AGENDA
ST. TAMMANY PARISH PLANNING COMMISSION MEETING
6:00PM – WEDNESDAY, FEBRUARY 14, 2018
ST. TAMMANY PARISH GOVERNMENT COMPLEX
PARISH COUNCIL CHAMBERS
21490 KOOP DRIVE, MANDEVILLE, LOUISIANA

TENTATIVE SUBDIVISION STAFF ANALYSIS REPORT
(Revised as of February 6, 2018)

CASE NO.: 2017-888-TP

PROPOSED SUBDIVISION NAME: LAKESHORE VILLAGES, PHASE 3

EXHIBIT

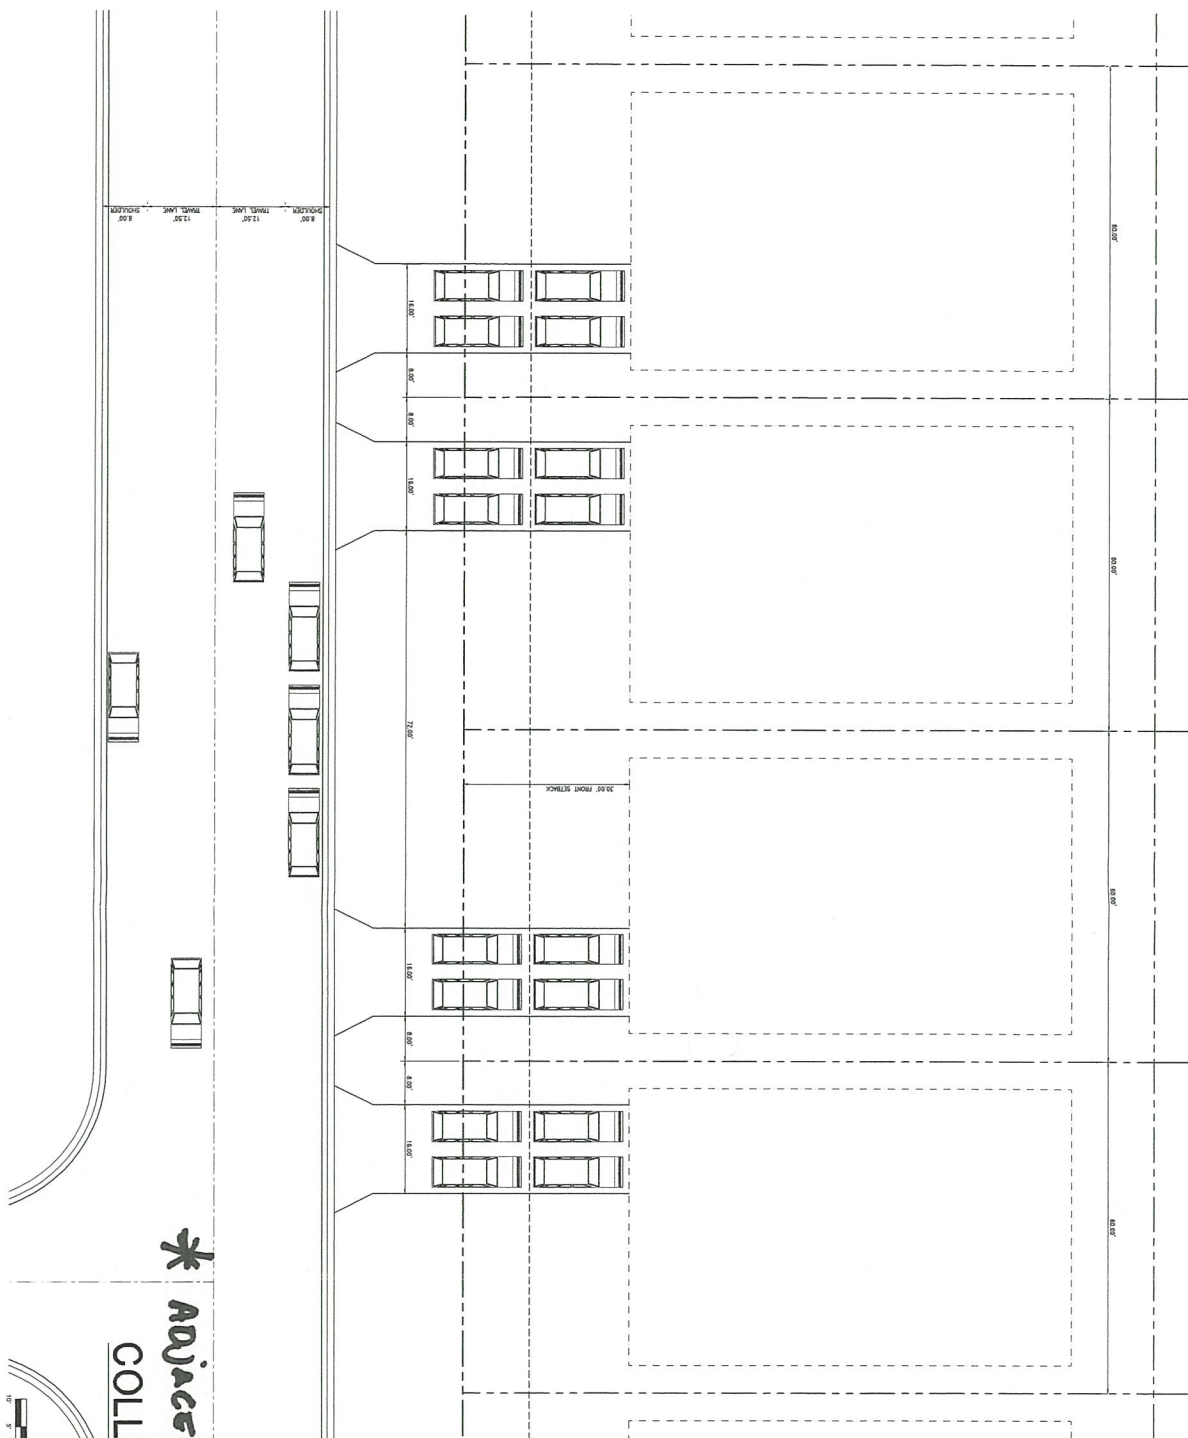
2. The staff is concerned that there will be too many driveway cuts for the now proposed sixty (60’) wide lots on the west side of Lakeshore Village East, which acts as the major collector road for the development as well as for future development to the north and west, and should therefore be limited insofar as the number of direct driveway accesses. Therefore, in order to mitigate this issue the staff recommends that the lots on the west side of the street be increased to a minimum of seventy-five (75’) feet in width and that contiguous driveway access points be established for every two (2) lots as suggested by the revisions made to the tentative plat depicting said driveway locations. By increasing said lot, widths to seventy-five (75’) feet will create 100’ long distances between each driveway access point.

1. Include in the notes section that the H.O.A. will own and maintain the required Green-spaces.
2. The developer is proposing to include parallel parking along the 90' wide collector road (Lakeshore Village North). Staff does not approve of the proposed design unless there is a median divider to control access and traffic flow.
3. Note 11 states as follows: "Dedication: All street rights-of-way as shown hereon are hereby dedicated to the perpetual use of the public for proper use. The collector roadway with a 90' right-of-way is to be owned and maintained by the Community Development District and the local roadways with 50' right-of-way are to be owned and maintained by St. Tammany Parish." Staff recommends that all streets within the subdivision either be owned and maintained by the CDD or Parish, not a mix of the two.

- Permitted driveway areas and a restrictive covenant were added to the plat in order to control the access points onto the collector roadway.
- D.R. Horton (DRH) will restrict lots 392, 393, 398, 463, 464, 510, 511, 528, and 529 to be side-loaded, which is shown in blue on the Tentative Exhibit and listed on the revised waiver request letter. Therefore, the driveway waiver exhibit has been revised to show lots that will remain front-loaded. Please note that lots 528 and 529 are lots that front the collector, and they are among the lots listed to be side-loaded. Therefore, there will be two less driveway cuts on the collector roadway.

- The Master Parks Plan was added as an enclosure for the waiver request letter.
- Please note on the Tentative Exhibit two intersections that will be all-way stops. This will aid in slowing down traffic along the collector roadway.
